**REQUEST**

**SUMMARY OF PETITION**

The petition proposes to amend the conditional site plan to allow for the construction of a hotel.

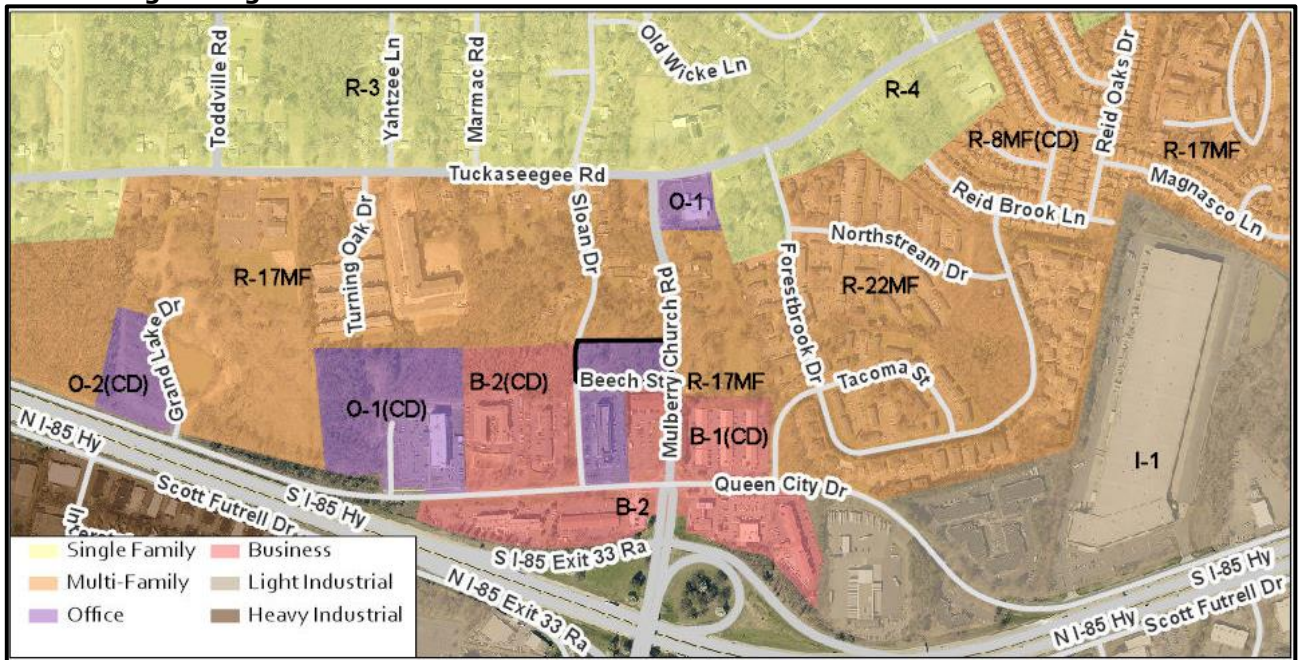
1. ~~Revise the site plan and conditional note(s) to commit to dedicate 35-foot right-of-way from Mulberry Road's existing centerline. The site plan should label and dimension the right-of-way from the road centerline.~~ **Addressed**
2. ~~The petitioner should revise the site plan and conditional note(s) to commit to dedicate 31.5-foot right-of-way from Sloan Drive's existing centerline. The site plan should label and dimension the right-of-way from the road centerline to incorporate the proposed 2.5-foot curb/gutter section, 8-foot planting strip, and 6-foot sidewalk transportation improvements. Please note, the proposed 8-foot sidewalk along the site's Sloan Drive and Mulberry Church Road frontages can be in a sidewalk utility easement.~~ **Addressed**

3. ~~Petitioner to work with CDOT on the abandonment of Beech Street prior to City Council decision or the site will need to be redesigned to remove parking out of the required setback.~~ **Addressed**

4. ~~If Beech Street is abandoned, the required side yard on the south side is 15'~~ **Addressed**
5. ~~Please re-label the northern buffer on plan as a Class B buffer.~~ **Addressed**

6. ~~Revise the plan to remove the request for 5-year vested rights~~ **Addressed**
